# **FIRE SAFETY INSPECTION REPORT**

**CROWN KNIT WEAR, LTD.  
PLOT NO. 781-782, VOGRA**

March 16, 2014

F-9 Egress

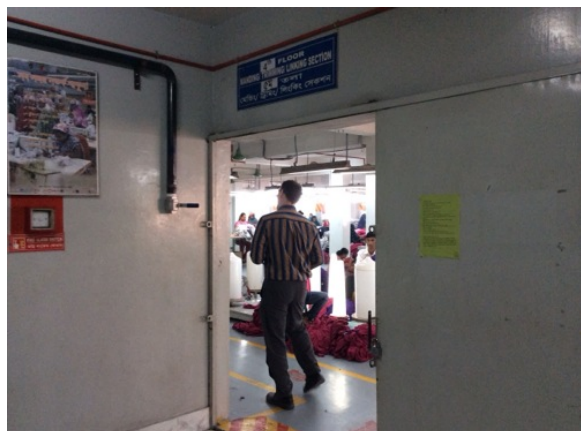
Collapsible gates / sliding doors are provided at building exits, and exit stairs.

Throughout building.

Replace all gates / sliding doors along the means of egress with side-hinged, swinging egress doors.

If locks are required for security reasons, utilize special door locking features complying with NFPA 101.
